Well Name: POKER LAKE UNIT 22 Well Location: T24S / R30E / SEC 22 / County or Parish/State:

Well Number: 157H Type of Well: CONVENTIONAL GAS Allottee or Tribe Name:

Sundry ID: 2697950

Type of Action: APD Change

WELL LOCATION AND ACREAGE DEDICATION PLAT

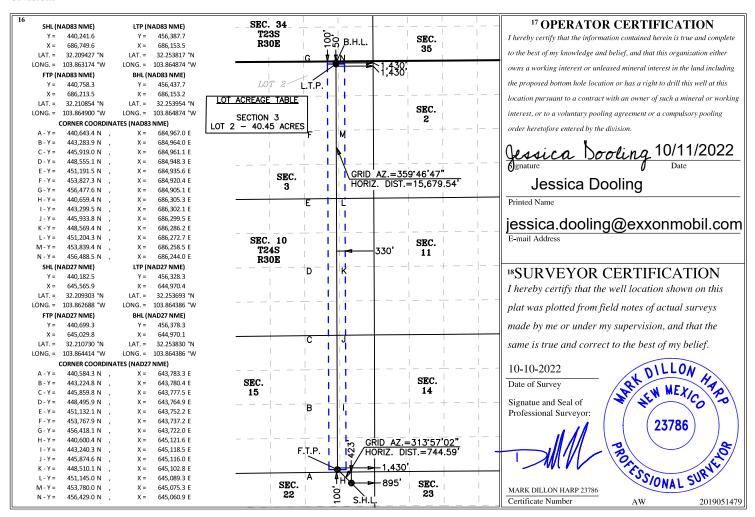
Procedure Description: ** Bottom Hole Location Change, First and Last Take Point Changes and Casing/Cement Changes XTO Permian Operating, LLC requests permission to make the following changes to the original APD: No Additional Surface Disturbance. Change BHL from 198'FNL & 1298'FEL to 50'FNL & 1430'FEL, Section 3-T24S-R30E Change FTP fr/100'FSL & 1357'FEL to 100'FSL & 1430'FEL Change LTP fr/328'FNL & 1298'FEL to 100'FNL & 1430'FEL Casing/Cement changes per the attached drilling program. Attachments: C102 Drilling Program Directional Plan

| | | | DO | | e Location ii | Different From | II Surrace | | |
|--------------------|-------------|----------|---------------|------------|---------------|------------------|---------------|----------------|--------|
| 2 | 3 | 24 S | 30 E | | 50 | NORTH | 1,430 | EAST | EDDY |
